Access Compliance Report Public Rights-of-Way (RR Crossings)

Intersection ID: 10038386	Main Street: SOUTH_BV	Location: N/A
ADA ID: 9D4530E734C9	Overall Compliance: No	Severity Score: 0.0
Codes/Mitigation Info/Possible Solution		Field Measurements/Component Compliance

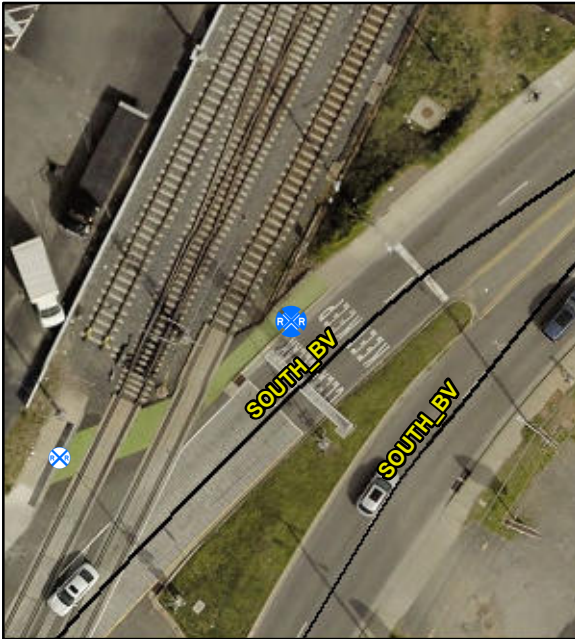
**Remove & Replace Detectable
Warning System. Provide Pedestrian
Gate. Remove & Replace Walking
Surface Adjacent to Rail.**

DWS OFFSET 266.0

R302.7.4, R305.1.4, R305.2.5
